ADDENDUM NO. 1

Contract No.: RFT 2025-003

**Tender – Reconstruction of John Street and Construction of Pedestrian Crossover (PXO)
at Queen St E & Fergus St S/Parkside Dr, Mount Forest**

DRAWING NUMBER **01**

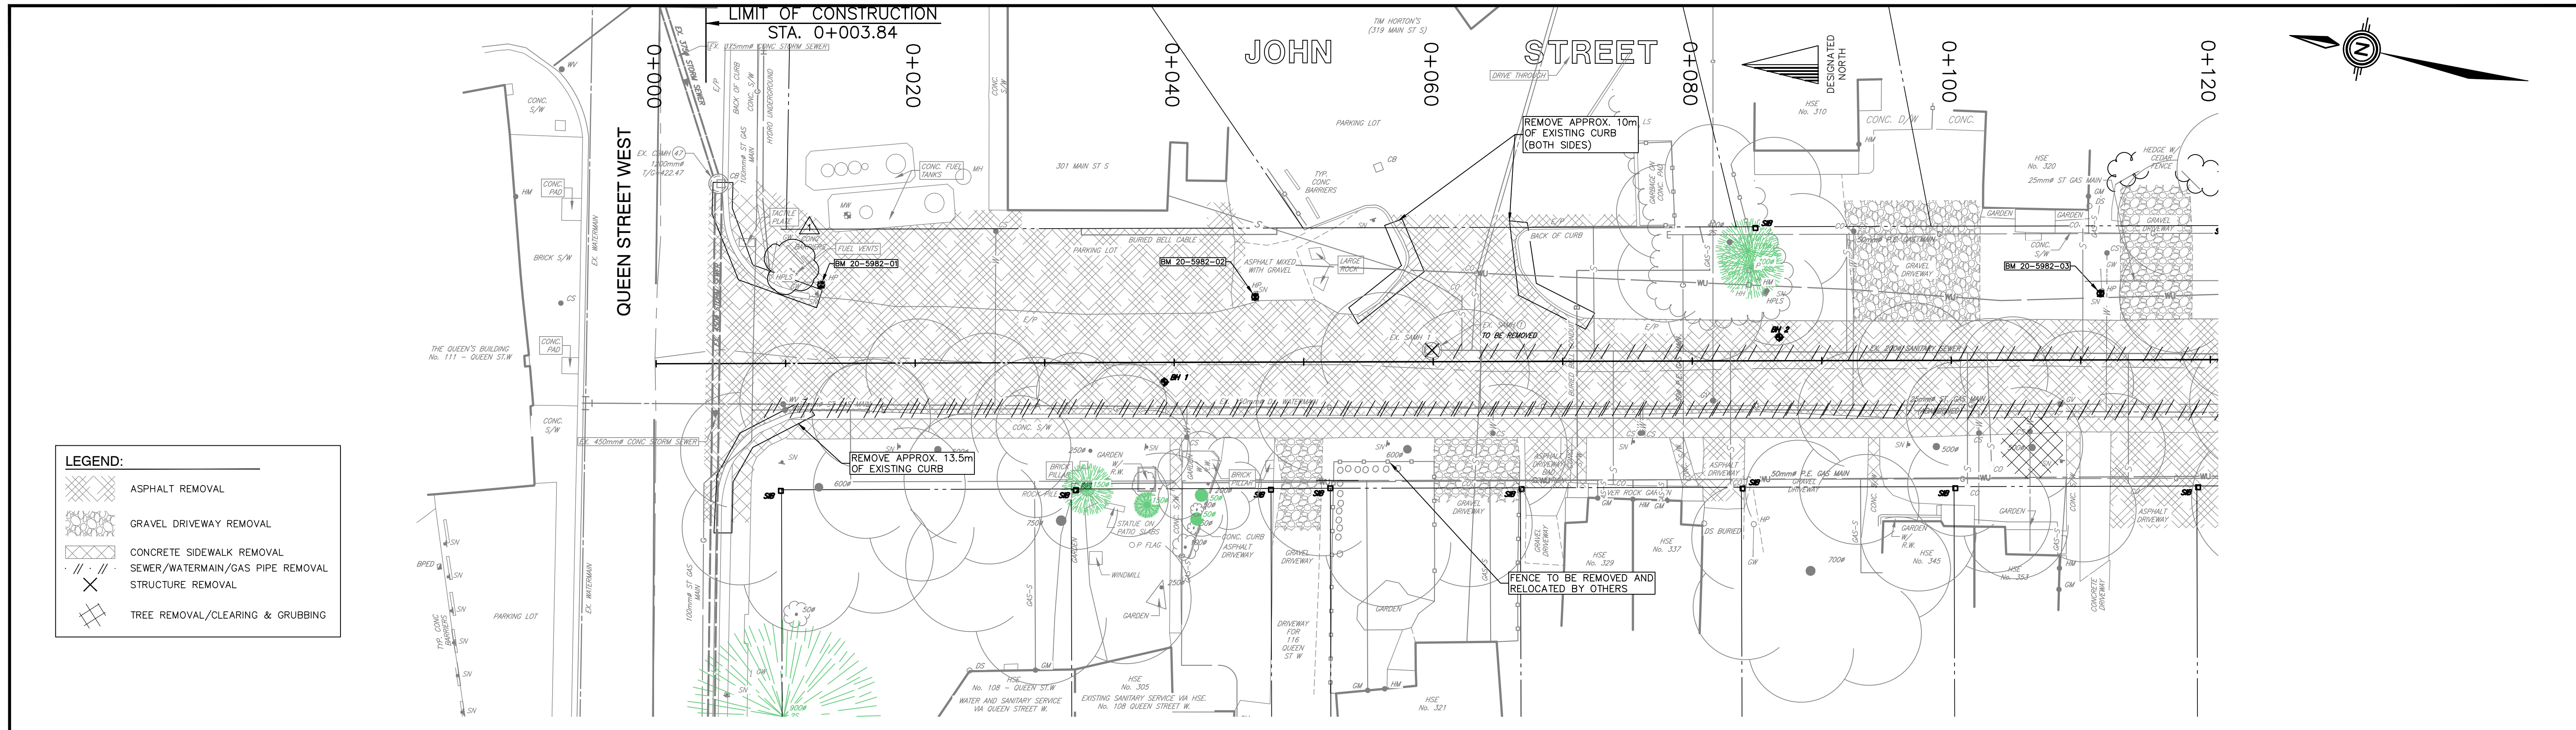
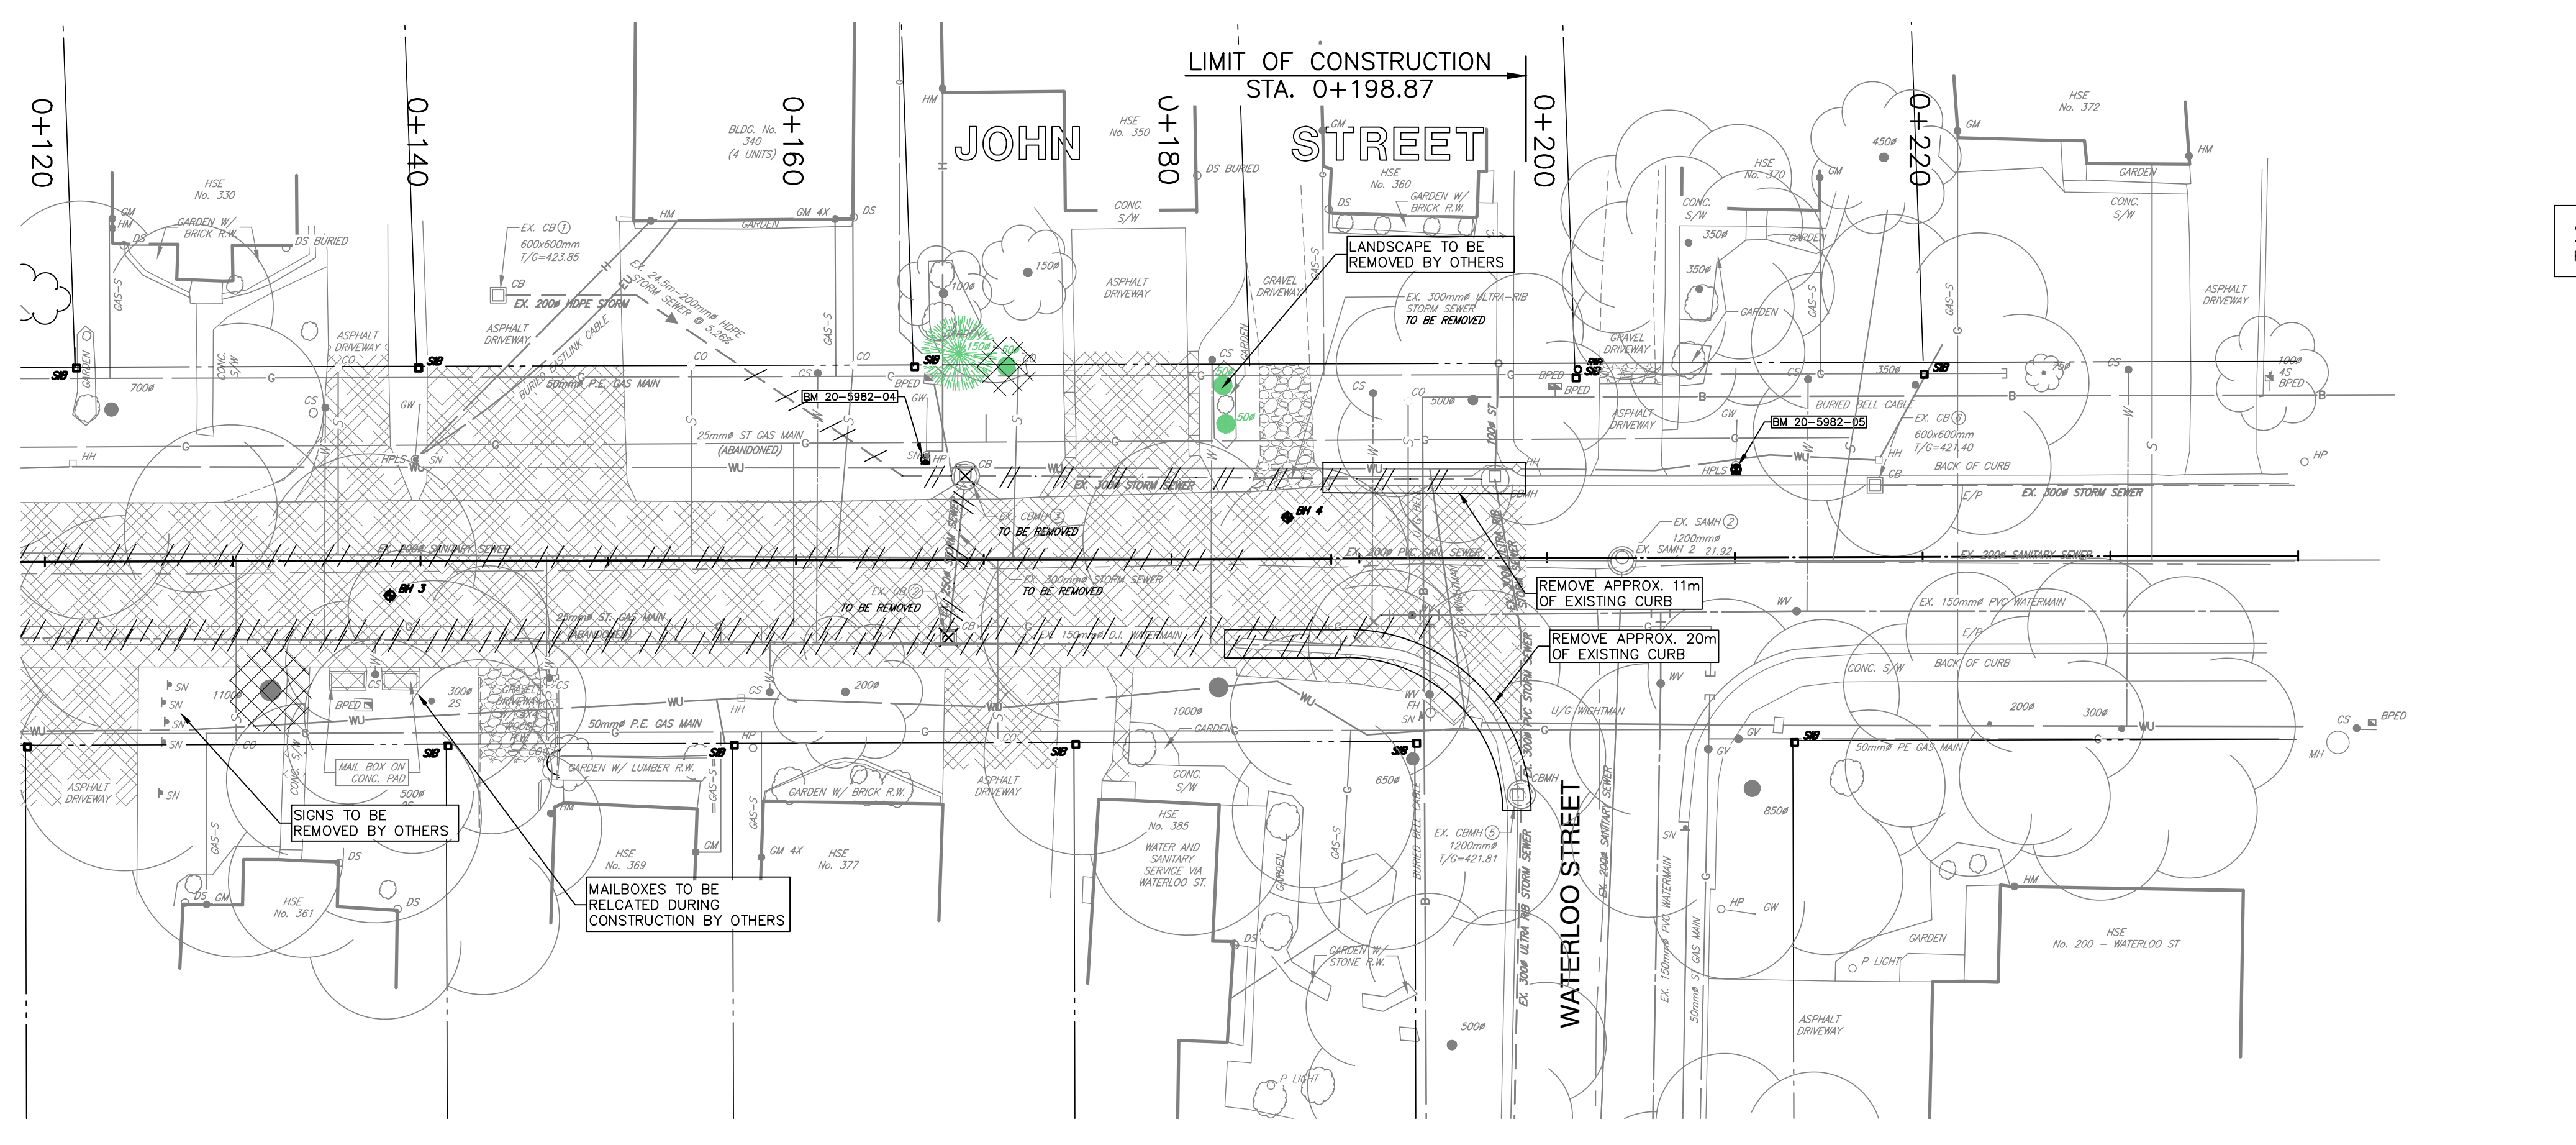
Drawing No. 01 – Removals Plan

Removed call out box at Sta. 0+011 Lt noting “Remove Fuel Vents & Cap Below Grade (Provisional)”.

ADDENDUM No. 1
 - REMOVED CALLOUT BOX WITH PROVISIONAL ITEM TO REMOVE FUEL VENTS AND CAP BELOW GRADE

PLAN AND PROFILE FROM QUEEN ST W TO STA. 0+120

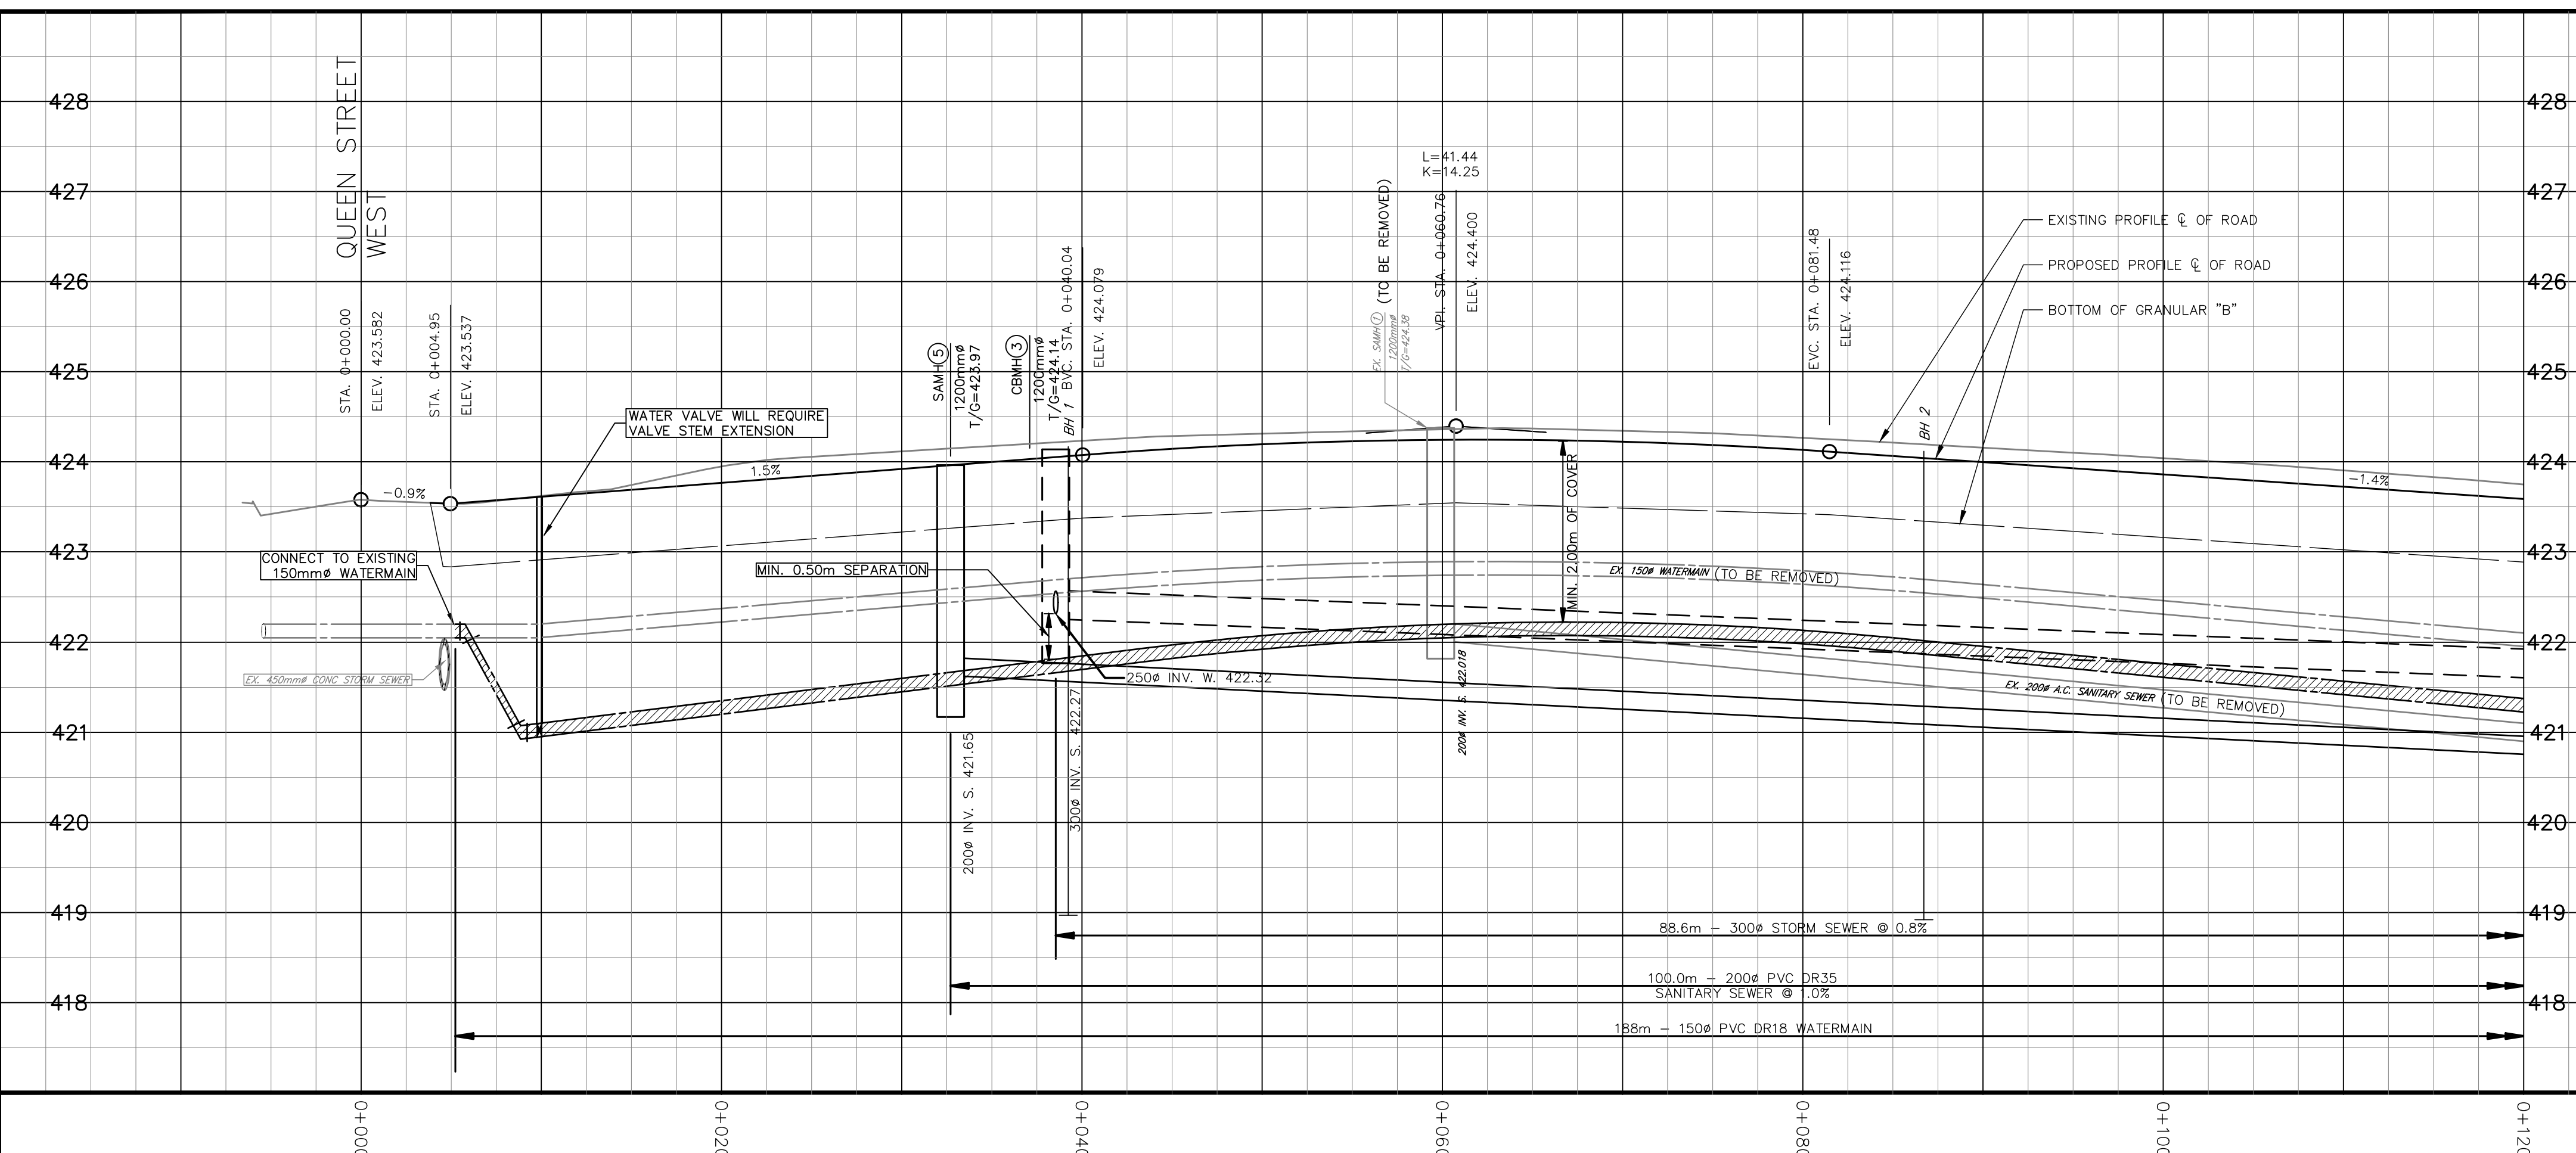
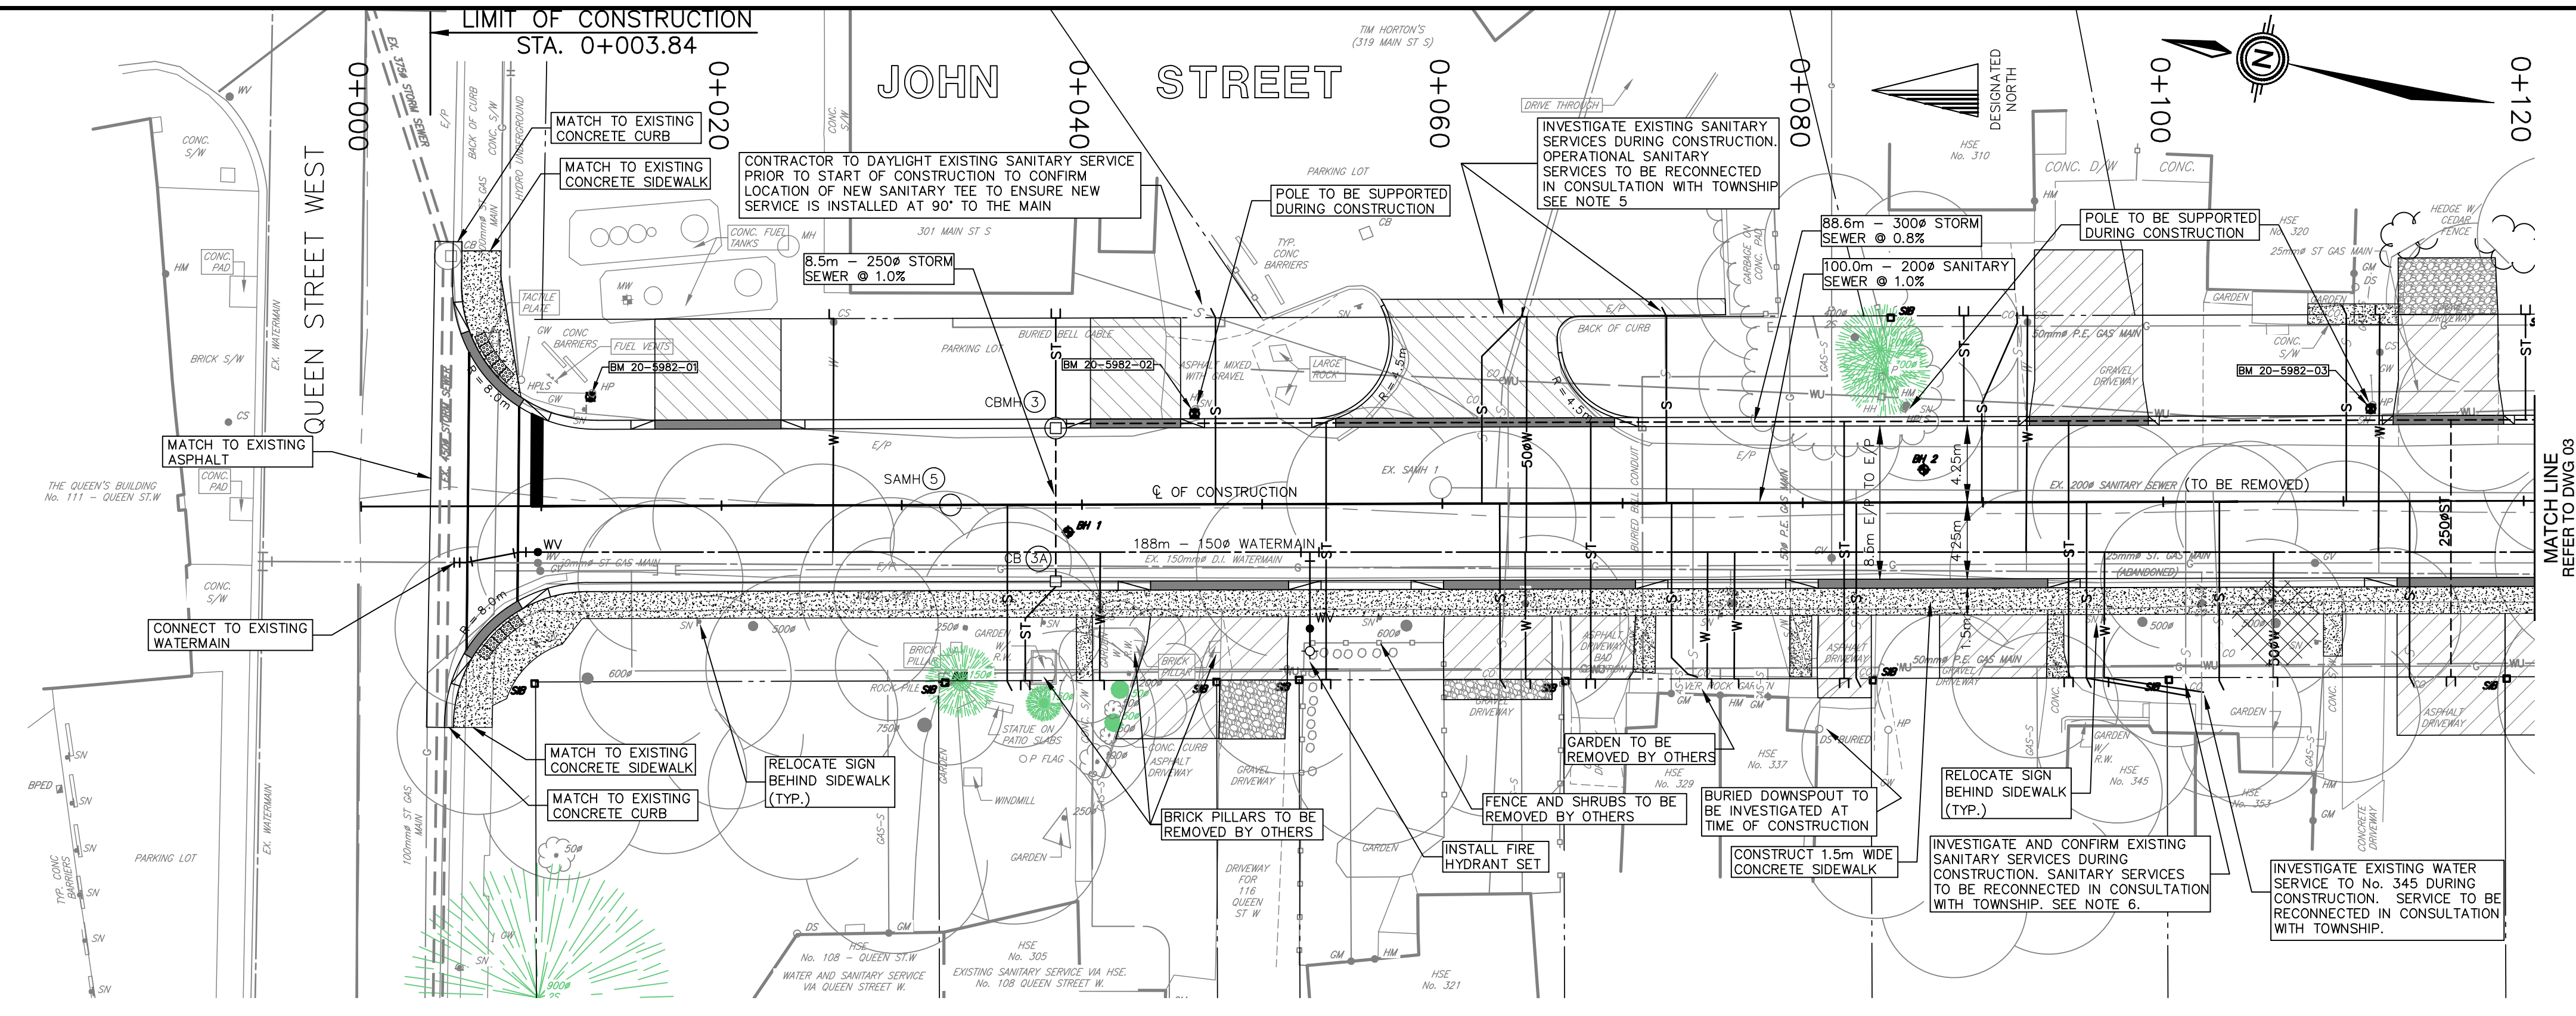
From: Township of Wellington North

Drawings show Commercial Driveways as 75mm HL3 and Spec says 90mm in 2 lifts of 45 mm. Which one is correct?

Drawing No. 02 – Plan and Profile from Queen St W to Sta. 0+120

Updated legend item for Commercial Driveways

ADDENDUM No. 1
-UPDATED LEGEND ITEM FOR COMMERCIAL DRIVEWAYS

Commercial driveways should be 50 mm HL4 overlain by 40 mm HL3 for a total depth of 90 mm. Per this Addendum, *Section C - Special Provisions – Item No. 1.40 - Hot Mix Asphalt HL3F for Commercial Driveways* and *RFT 2025-003 Issued for Tender Drawing Set* have been revised to update the requirements for commercial driveways.

-  150mm GRAN. "A",
150mm GRAN. "B"
-  50mm HL.3C, 150mm GRAN. "A",
150mm GRAN. "B"
-  40mm HL.3, 50mm HL.4, 150mm GRAN. "A",
150mm GRAN. "B" (COMMERCIAL)
-  CONCRETE SIDEWALK
-  TACTILE PLATE AS PER OPSD 310.039
-  DROP CURB
-  CURB TRANSITION
-  PROPOSED WATER SERVICE
-  PROPOSED SANITARY SERVICE
-  PROPOSED STORM SERVICE
-  WATER VALVE
-  TREE REMOVAL
